Shared-Use Nonmotorized (SUN) Trail Network

A Northern alignment is proposed for a 4.7 mile long SUNTRAIL section. fpn 429823-1

Aerial view of the typical environment along 4.7 mile project length.

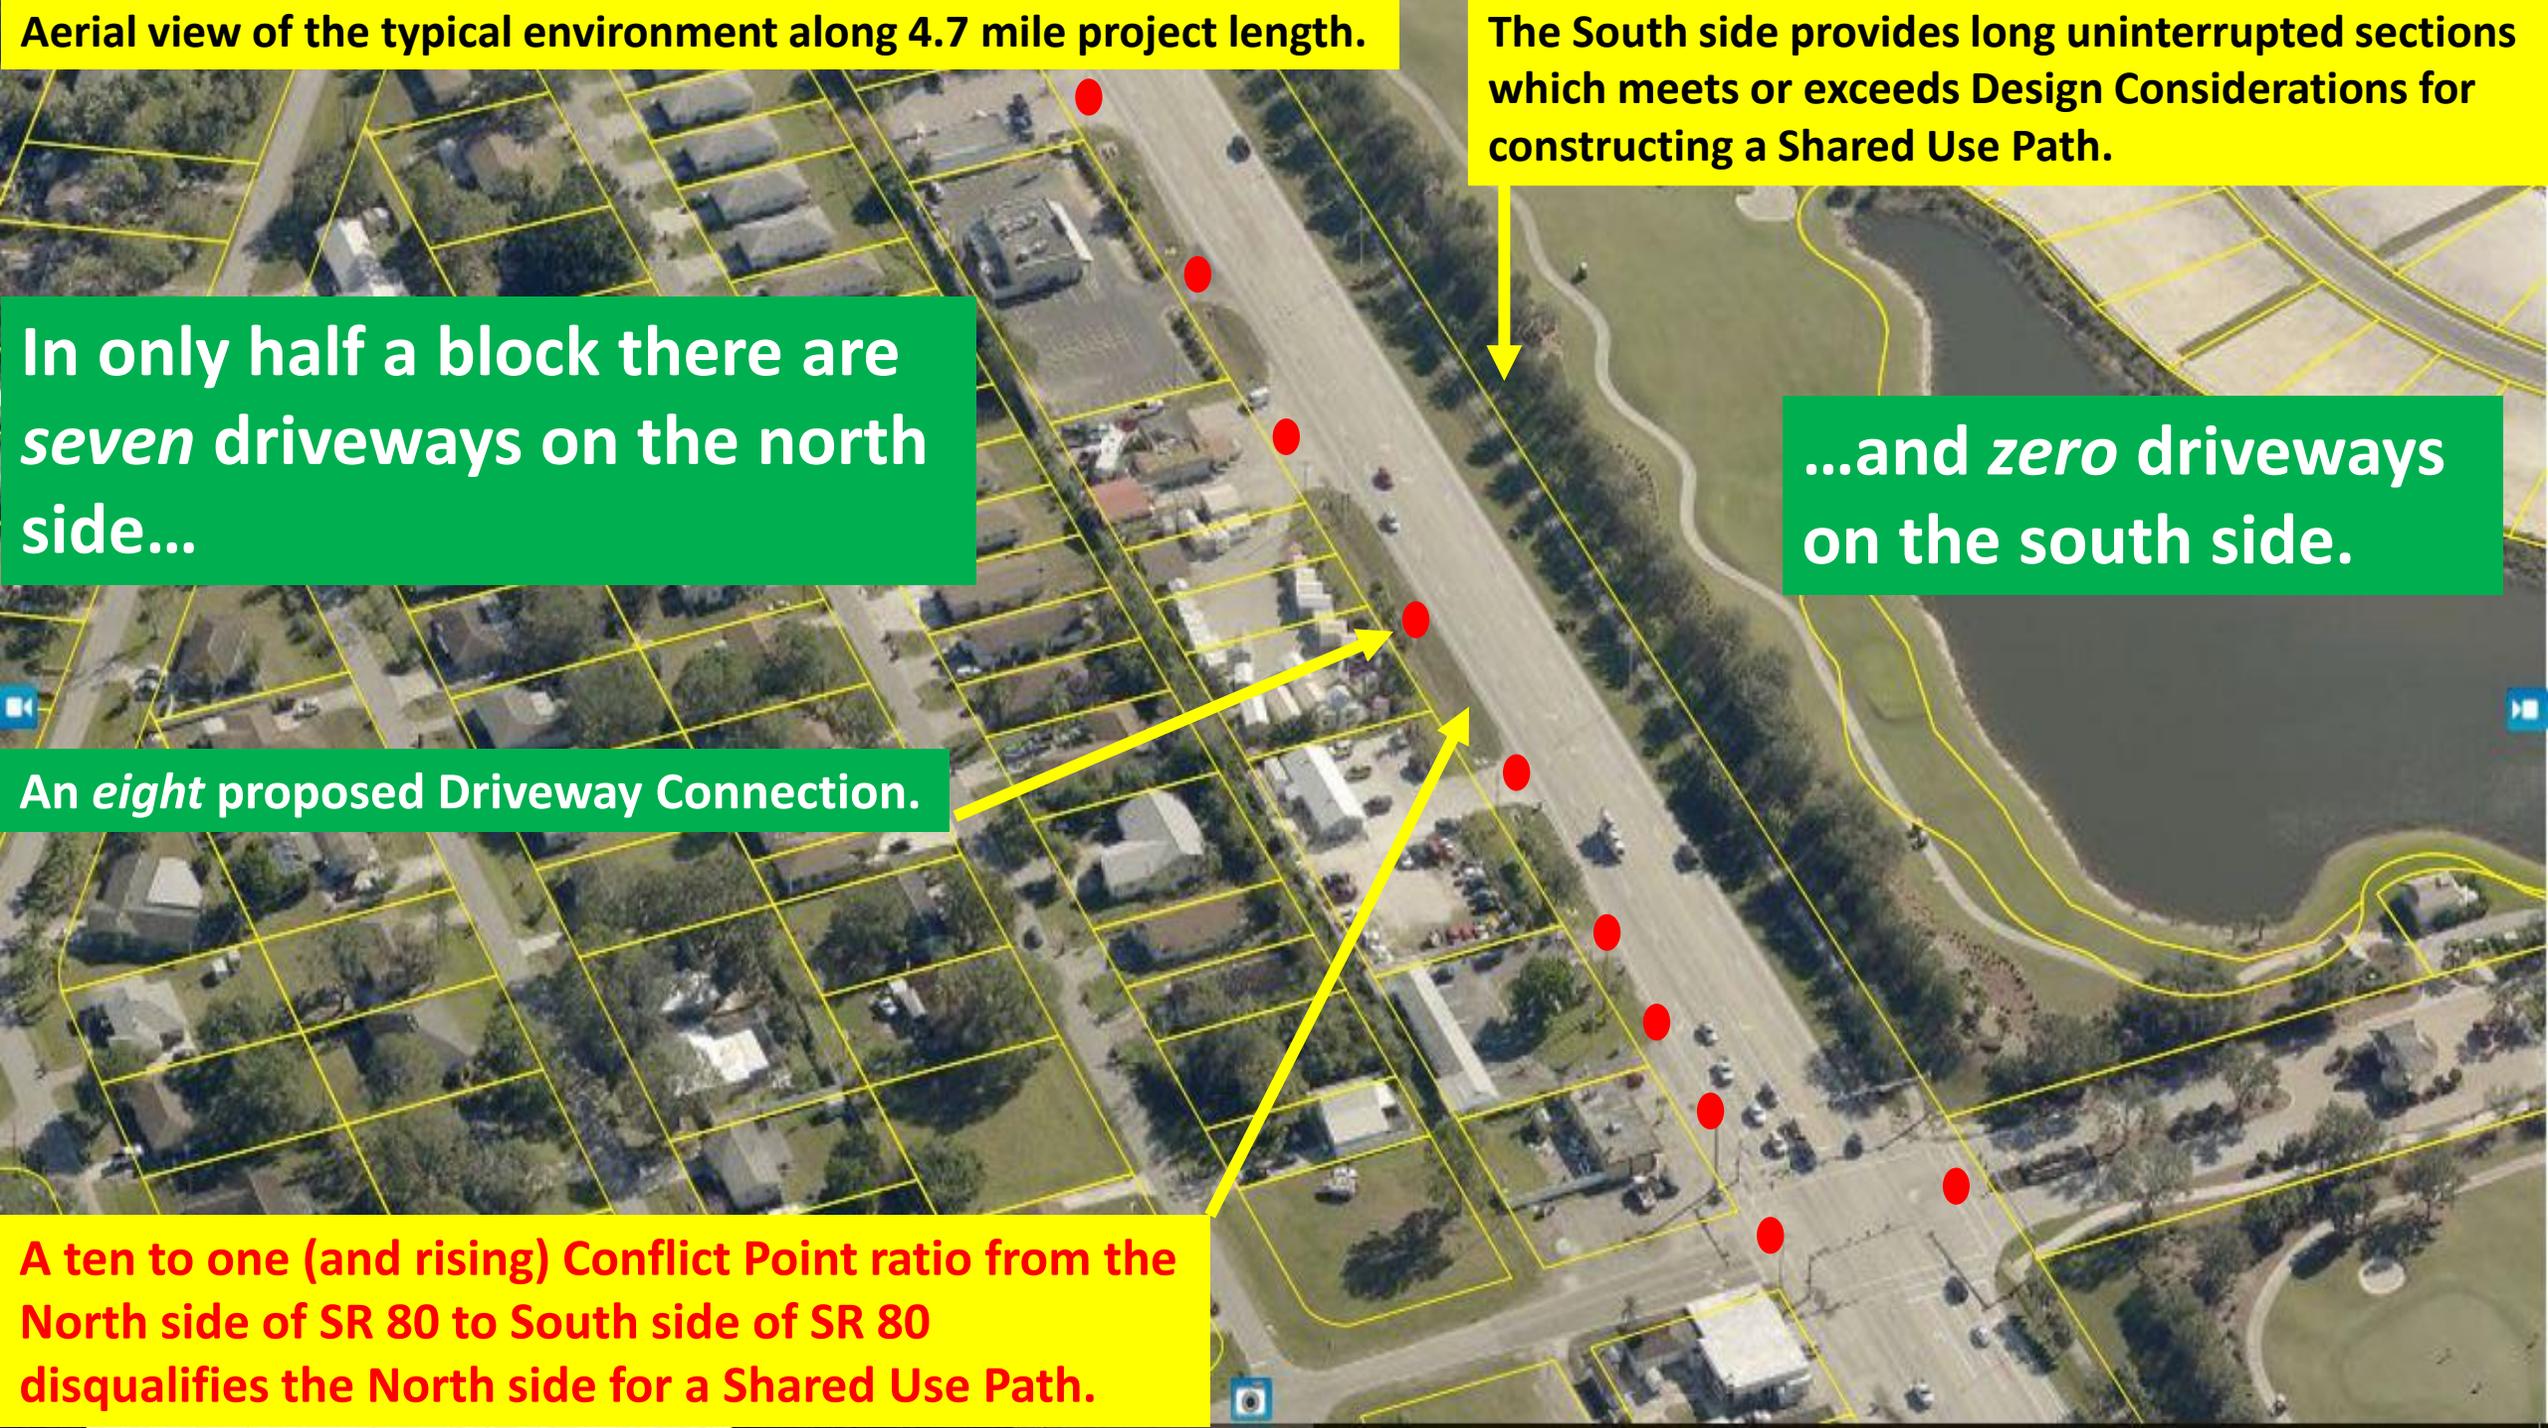
The South side provides long uninterrupted sections which meets or exceeds Design Considerations for constructing a Shared Use Path.

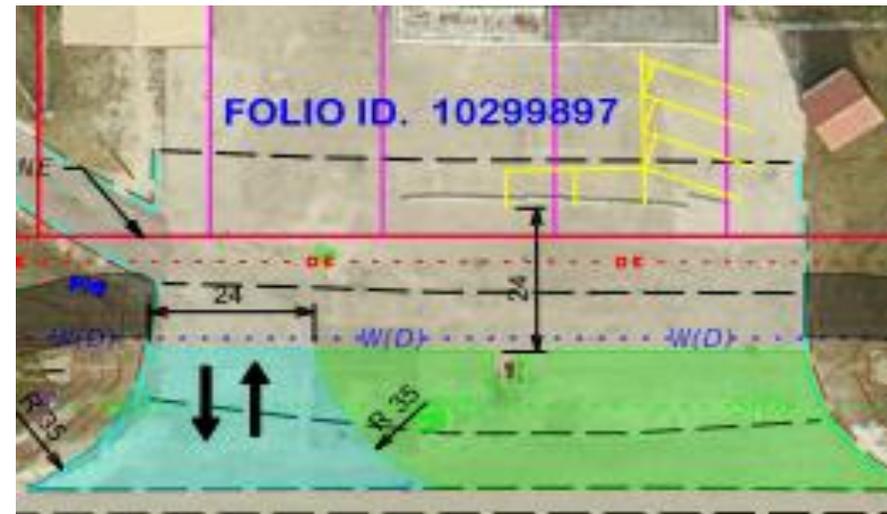
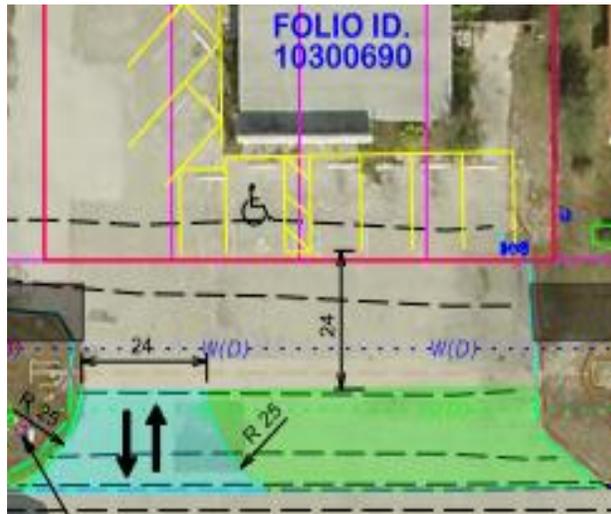
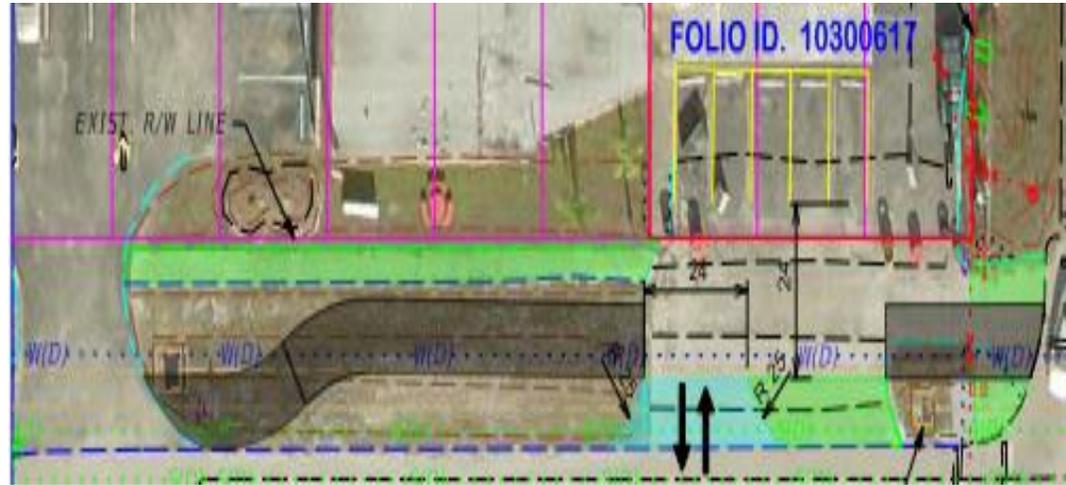
In only half a block there are *seven* driveways on the north side...

...and *zero* driveways on the south side.

An *eight* proposed Driveway Connection.

A ten to one (and rising) Conflict Point ratio from the North side of SR 80 to South side of SR 80 disqualifies the North side for a Shared Use Path.

Without taking existing businesses, the proposed 8' and 10' wide Bike Path sections will have unavoidable gaps in between to allow reasonable access to retrofit nonconforming grandfathered accesses.

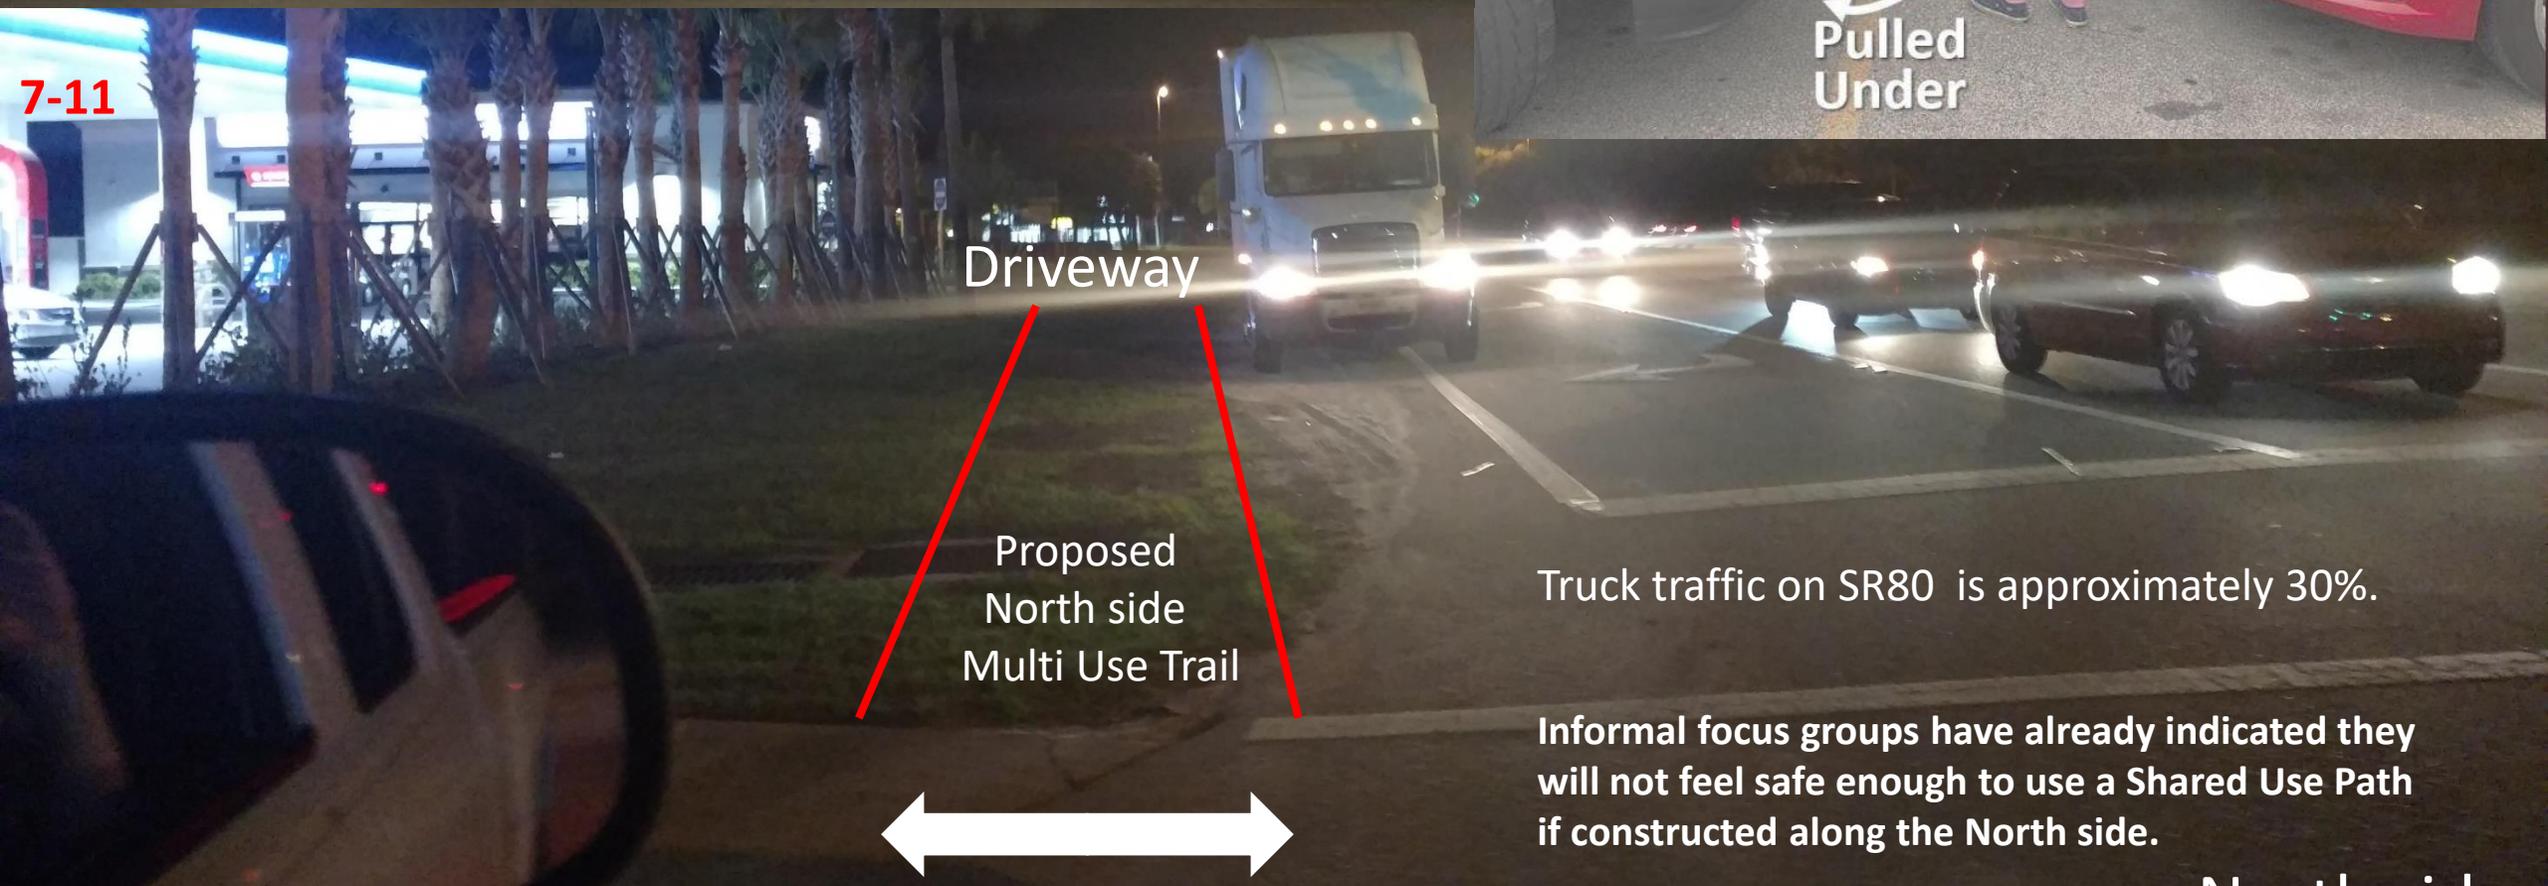
The North side places the Path too close to the road.

South side provides Shade and Separation from the Roadway.

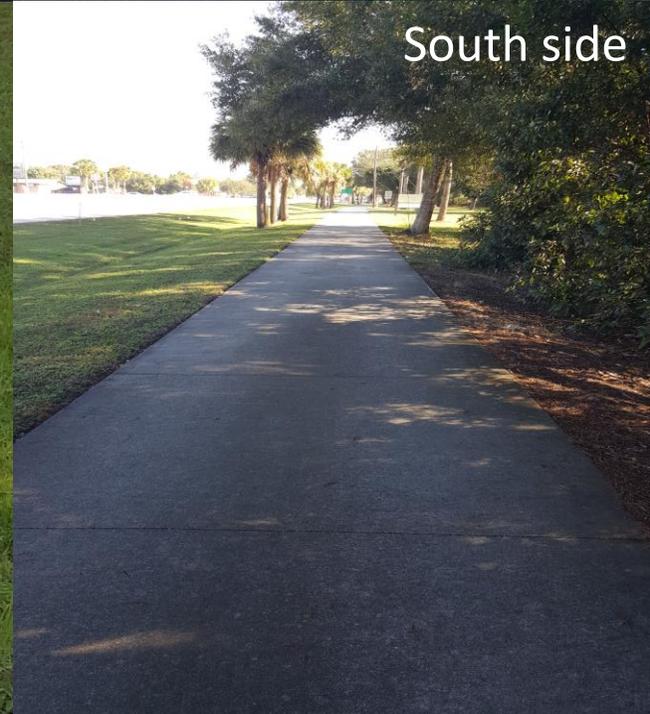
By far, the South side is the Safest location for the Statewide SUN Trail Network

- The South side offers a desirable environment for a Multi Use Trail with greater benefit to all.
- The pathway will be set back further from vehicle traffic with a deep drainage swale as a buffer.
- The Pathway will not have narrow pinch points.

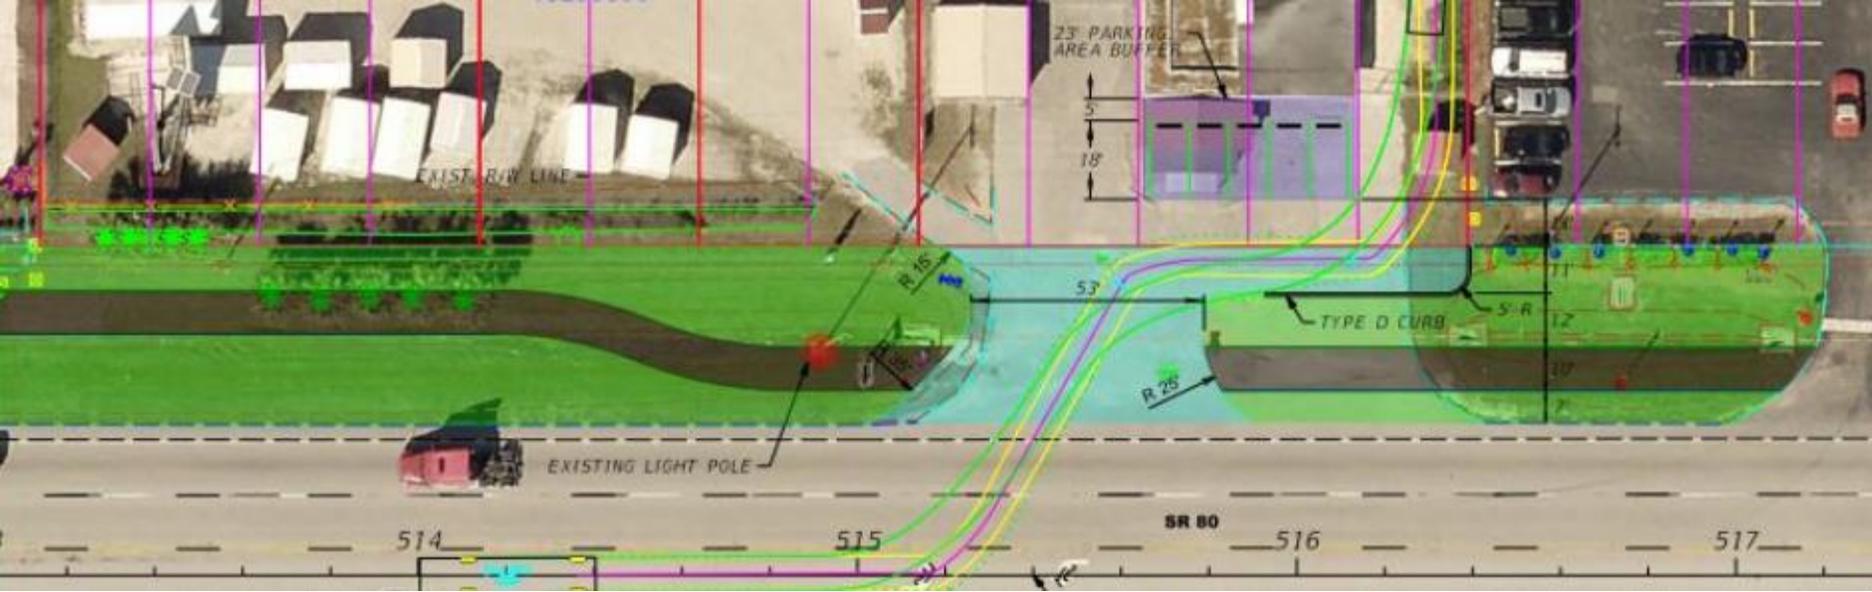
The North side project will terminate with no immediate plans to widen the bridge over the Orange River.

Connectivity can only be achieved with the South side project.

The South side will benefit from the existing pedestrian crossing (shown in blue) already separated and protected from SR 80 traffic by a concrete barrier.

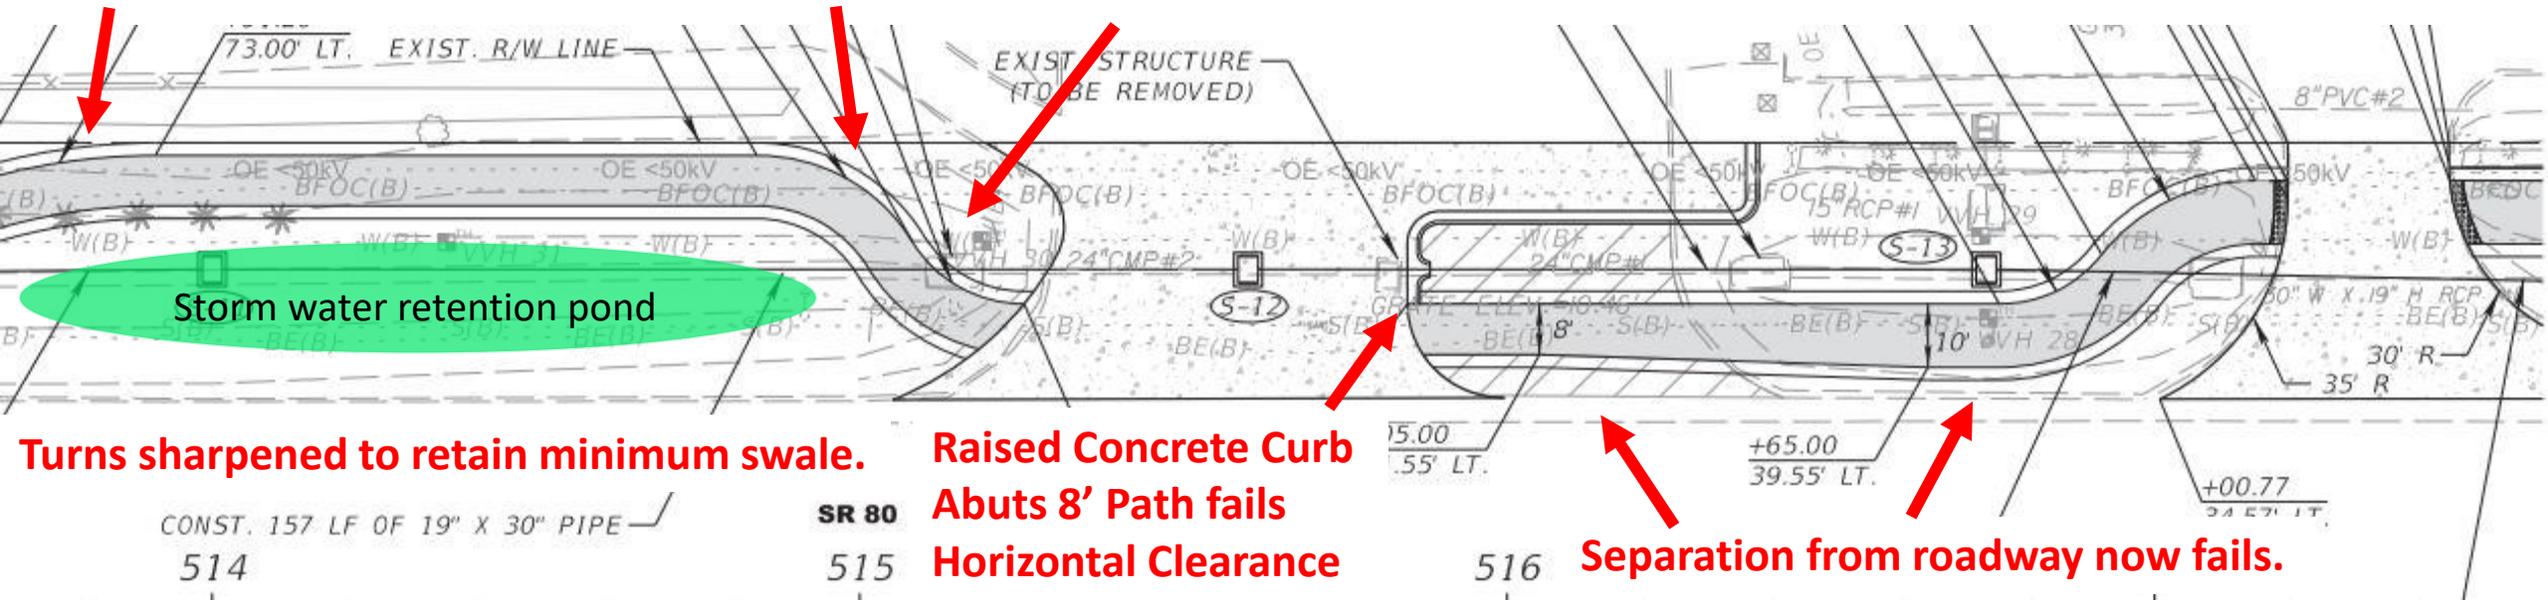
Image to the left was for a Conceptual 10' wide mostly straight Shared Use Path, until 5-15-20 when it suddenly became a largely 8' wide asphalt sidewalk with excessive curves added to not impact stormwater drainage any more than it already is.

Above image was a conceptual design for 10' wide Multi Use Trail along the North side. The bottom image is reality of the same road sections after recent revisions on 5-15-20.

Width reduced to non-conforming 8' wide

Curve fails FDM by more than 4 times the FDM Minimum Radii.

Turns sharpened to retain minimum swale.

Raised Concrete Curb Abuts 8' Path fails Horizontal Clearance

Separation from roadway now fails.
